Proposal for draft amendments to global technical regulation No. 2

A. PROPOSAL

Figure 1: Effects of Fuel Quality on Motor Cycle Emissions

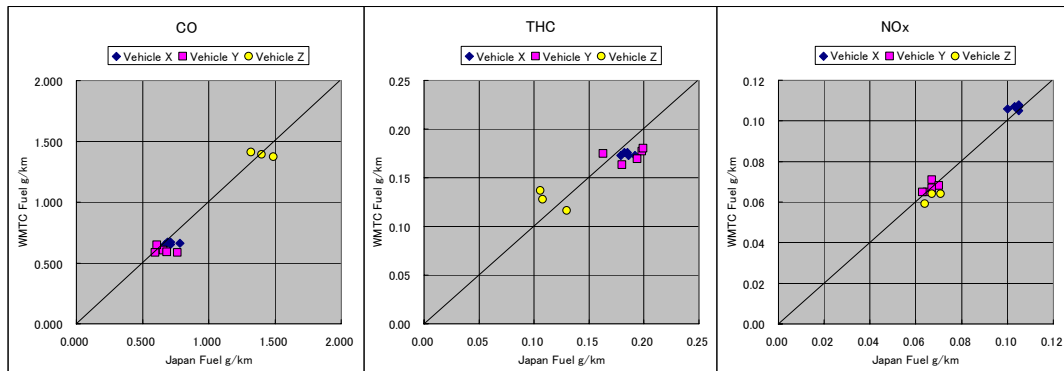
A comparison study was performed using three motorcycles in order to check the emission tendency of CO, THC, and NOx. The test results showed no significant difference in emission characteristics between the cases where the Japanese fuel and the fuels in Annex 2 (A.2.1.) were used. The details of the test results are shown in Figures 1-3 and Table 1 below.

The Japanese fuel can be used as an alternative fuel for paragraph 6.4. for compliance with the principal emission limits in reference to Part A paragraph 4(e).
